March 11, 1999

Refer to: HMHS-B50

In your January 25, 1999, letter to the Director of the Federal Highway Administration's Office of Engineering, you requested acceptance of two bridge rail designs that were developed and tested for use on the National Highway System (NHS) by the New England Transportation Consortium (NETC).

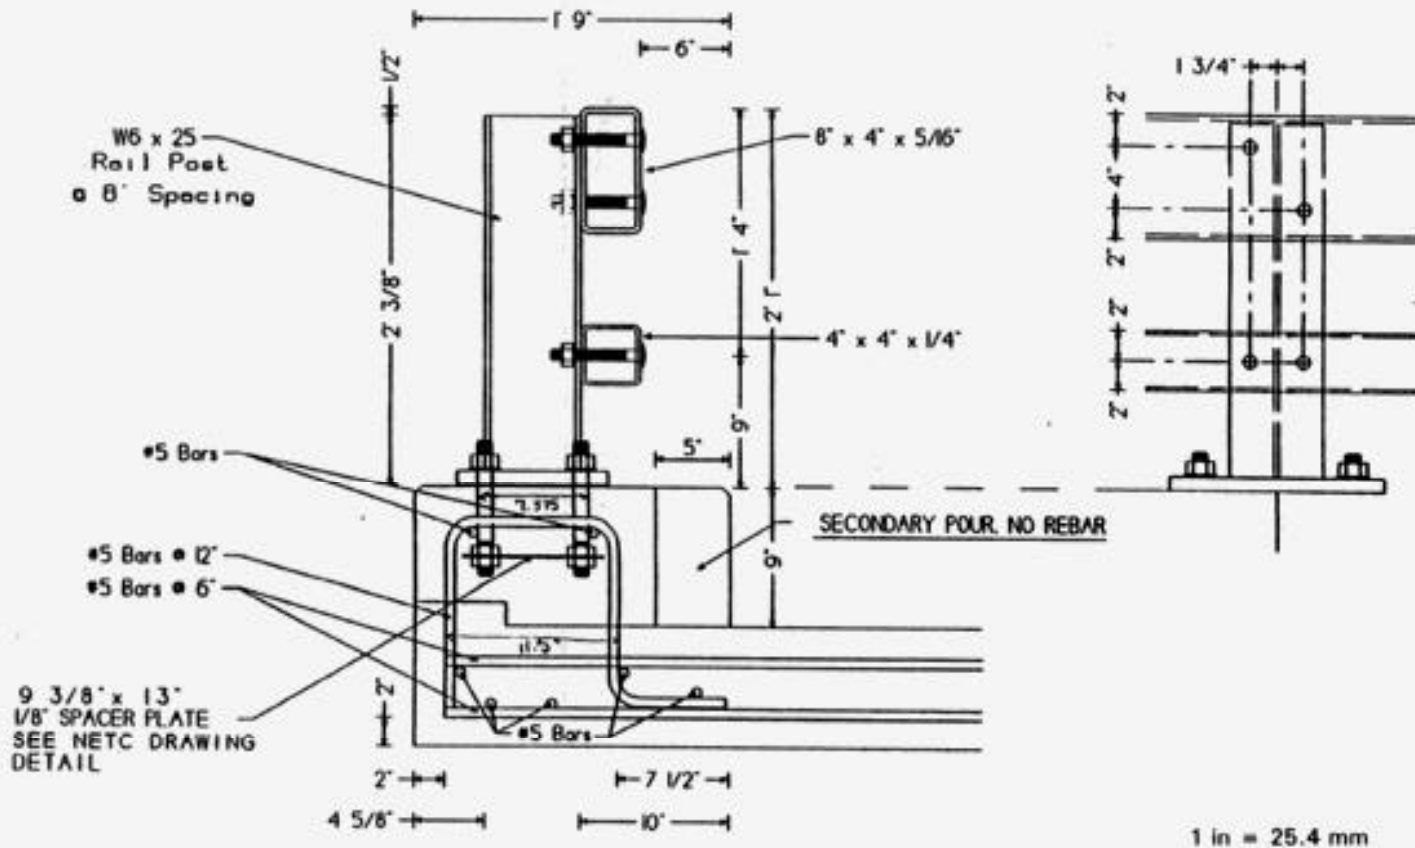
The first design is the NETC 2-Bar Curb-Mounted Bridge Railing shown as Enclosure 1. This design was tested to Performance Level 2 (PL-2) in accordance with the AASHTO Guide Specifications for Bridge Railings and was effectively accepted as an NCHRP Report 350 Test Level 4 (TL-4) railing by its inclusion in the summary listings attached to my May 30, 1997 memorandum on crash testing of bridge railings.

Based on the information you provided for our review, we conclude that both the NETC 2-Bar Curb-Mounted Bridge Rail and the 4-Bar Sidewalk-Mounted Bridge Rail are acceptable as TL-4 designs and may be used on the NHS when selected by a transportation agency. We understand that neither design is proprietary and that anyone wishing to obtain detailed plans and specifications may contact you by telephone at (860) 258-0309 or via e-mail at james.simes@po.state.ct.us. We further understand that the NETC is currently developing transitions to be tested in the near future for use with these two bridge railings.

Figure 1. Schematic of the test installation for test 471470-18.

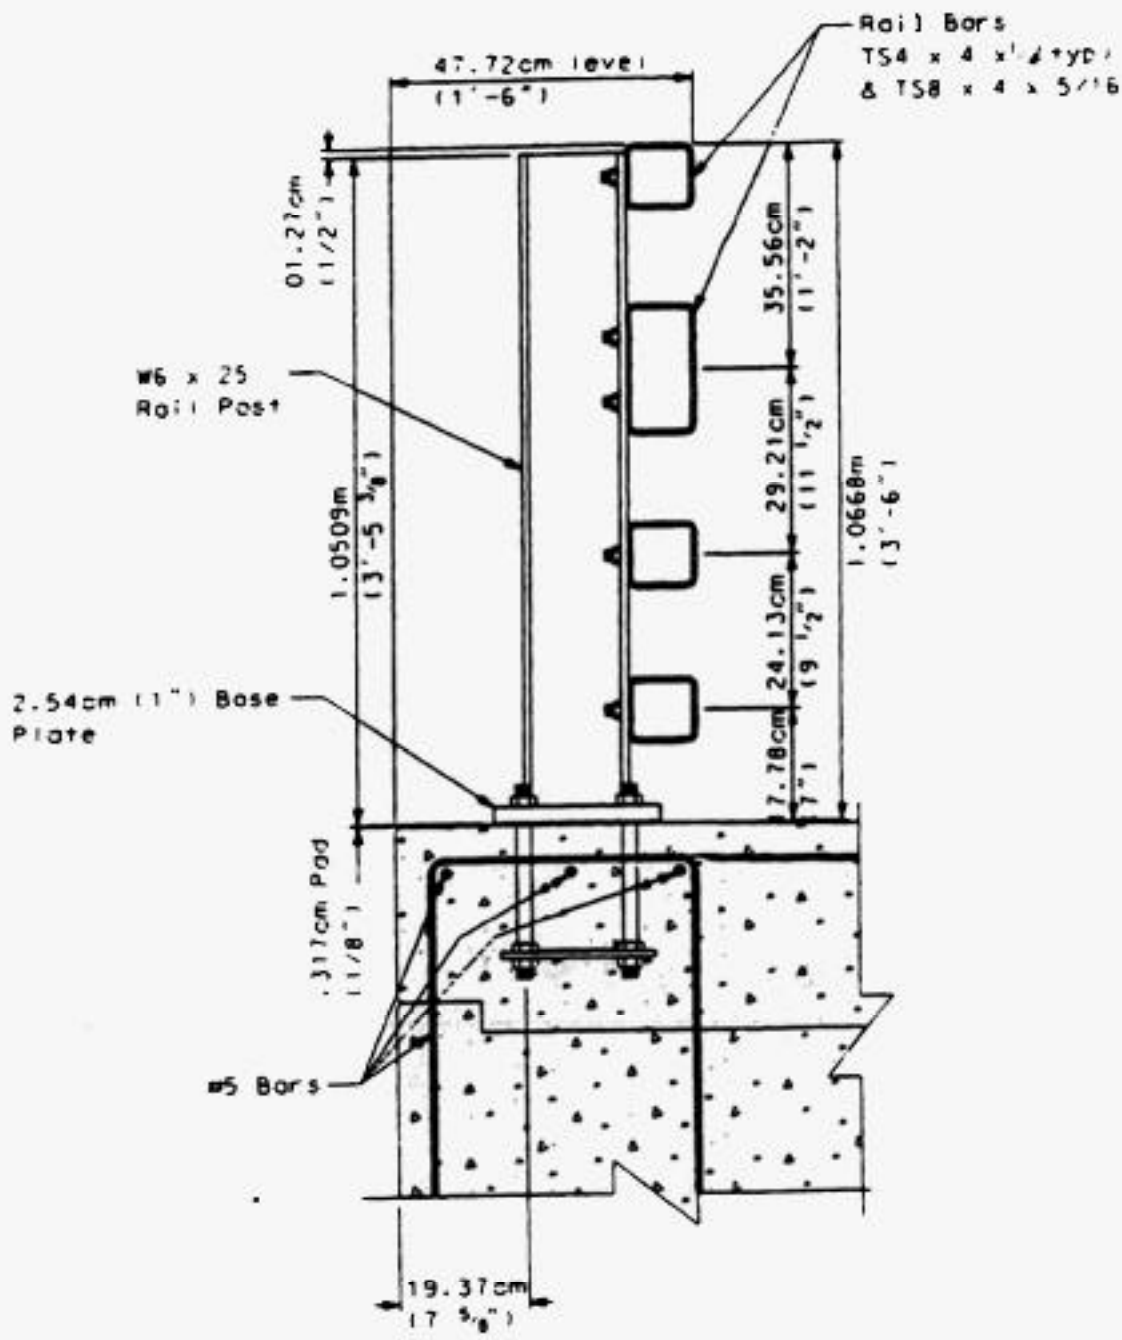
The second design is the NETC 4-Bar Sidewalk-Mounted Bridge Railing shown as Enclosure 2, and documented in four publications, FHWA-RD-99-027, FHWA-RD-99-028, FHWA-RD-99-029, and FHWA-RD-99-030, each entitled "Full-Scale Crash Evaluation of Sidewalk-Mounted Steel Bridge Railing". Review of each crash test report showed that the 4-Bar Bridge Railing met all appropriate evaluation criteria for an NCHRP Report 350 traffic barrier at TL-4. Summary sheets on each of the three tests that were conducted are attached as Enclosure 3.
